Third Party Observation To An Bord Pleanála

N63 Liss to Abbey Realignment Scheme

An Bord Pleanála Ref: ABP HA07.312875-22

Lucy Woods,
Rose Villa, Liss,
Abbeyknockmoy,
Tuam,
Co. Galway
H54 FW71

Proposed footpath, parking and pedestrian crossing arrangements to the front of Rose Villa

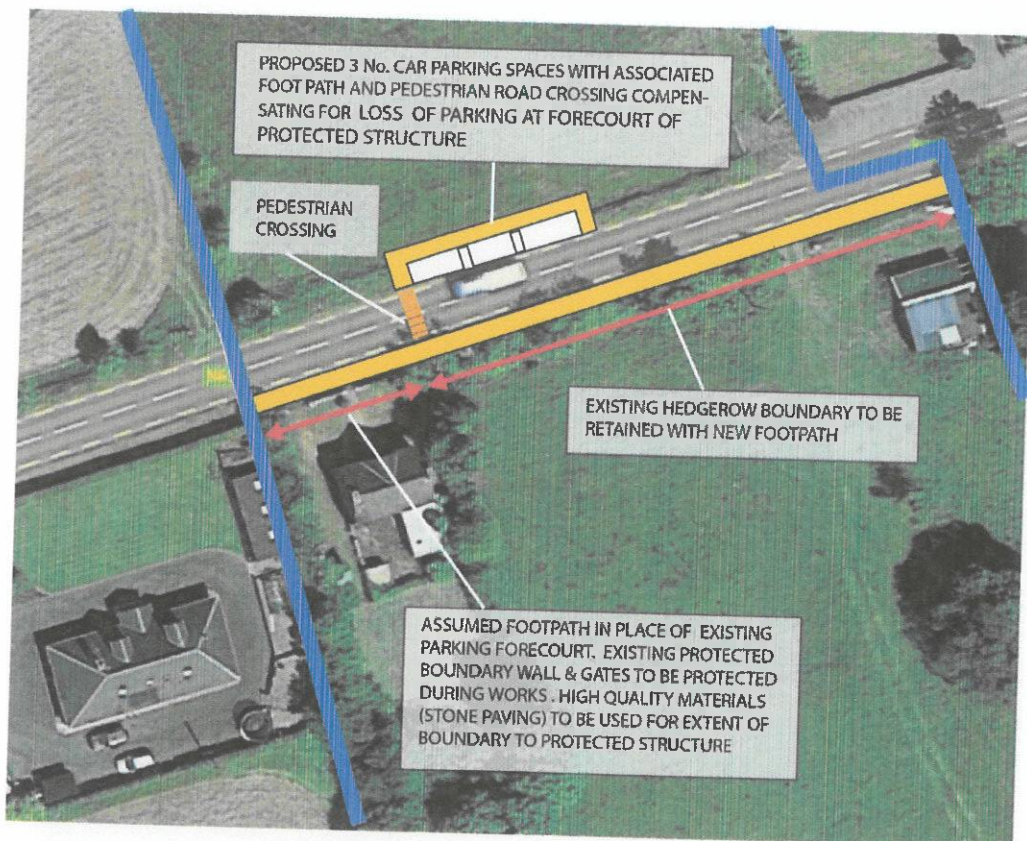
Item 1 - We note that our client's use of the property is not properly recognised in the works as proposed. Our client uses the forecourt to the existing dwelling as a parking area. The proposed works will remove the forecourt car parking area and as such this will disadvantage our client and diminish the use of the property. We request that the design is revisited, and that three parking spaces are incorporated on the northern side of the of the road located to the east of the dwelling frontage. We also request that a crossing point and footpath to the car parking is provided. We also request that the traffic speeds on the existing road will be reduced to 30km / hour. We note that there are a number of advantages to this proposal.

- The provision of car parking spaces will ensure that our clients use of the property is not diminished.
- The provision of parking on the street, and a crossing point between the north and south will reduce traffic speeds. This is in accordance with the Design Manual For Urban Roads and Streets (DMURS).
- The provision of a crossing point from the northern side of the street to the south will provide safe access across the road for the existing dwelling to access the northern lands on foot.
